Docket No. 50-443

Seabrook Station  
License Amendment Request 01-10  
“Relocation of Cycle-Specific Parameters to the Core Operating Limits Report”

Facility Operating License NPF-86  
Docket No. 50-443  
License Amendment Request 01-10  
Relocation of Cycle-Specific Parameters to the Core Operating Limits Report

Figure 2.1-1

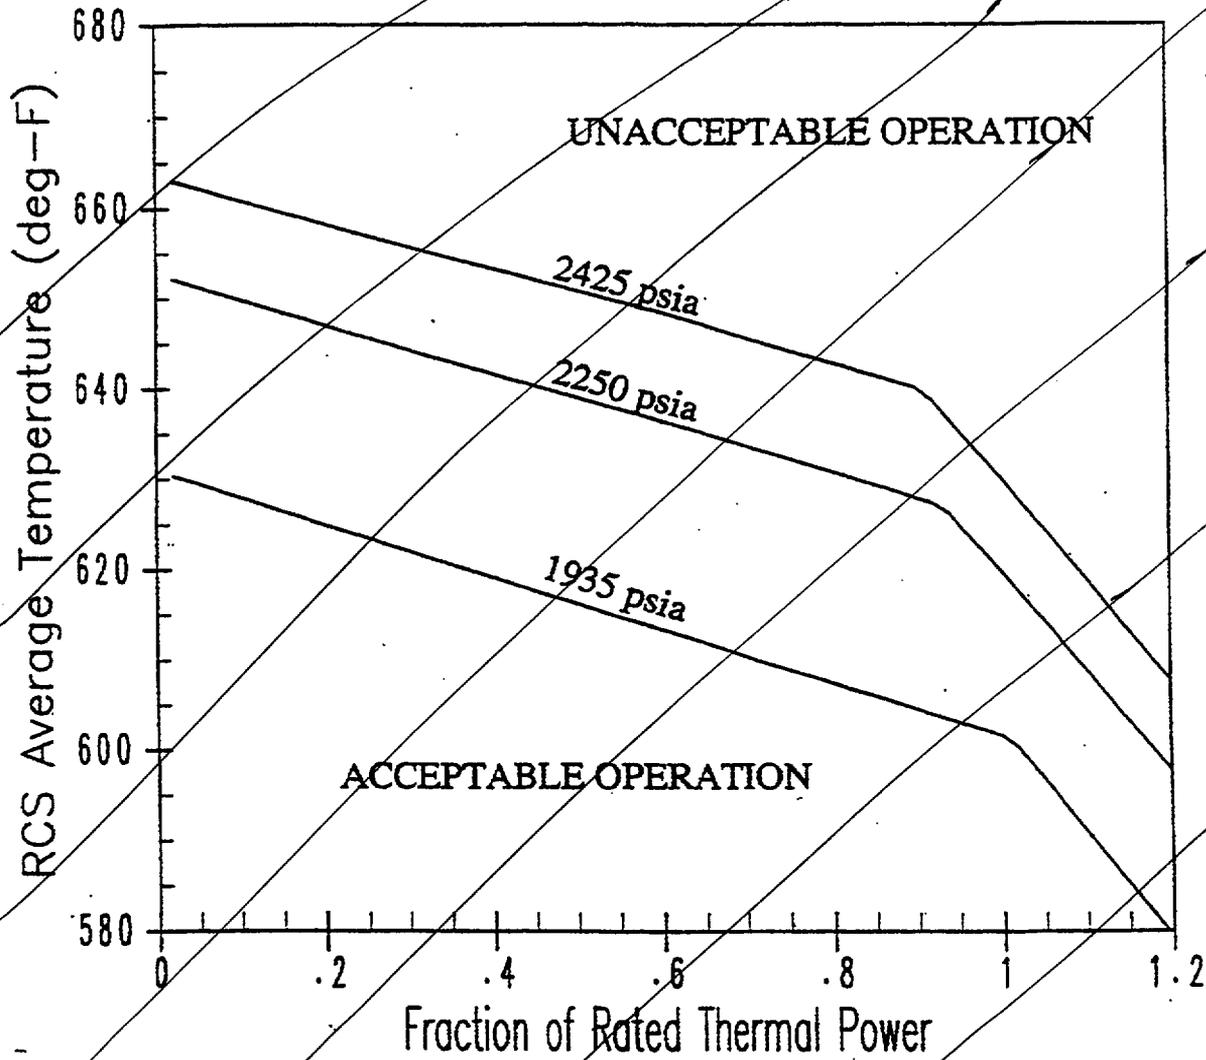
In addition, LAR 01-10 proposes changes to TS 2.1, “Safety Limits,” to relocate Figure 2.1-1, “Reactor Core Safety Limits-Four Loops in Operation,” to the COLR; and revise TSs 2.1.1 and 2.1.2 limiting conditions and actions so as to be consistent with the improved Standard Technical Specifications (ITS) – Westinghouse Plants, NUREG-1431, Revision 2. Also proposed is the relocation of DNB-related parameters, specified in TS 3/4.2.5, to the COLR.

(THIS FIGURE IS NOT USED)

(THIS FIGURE IS NOT USED)

In MODES 1 and 2, the combination of THERMAL POWER, Reactor Coolant System (RCS) highest loop average temperature, and pressurizer pressure shall not exceed the limits specified in the COLR; and the following SLs shall not be exceeded:
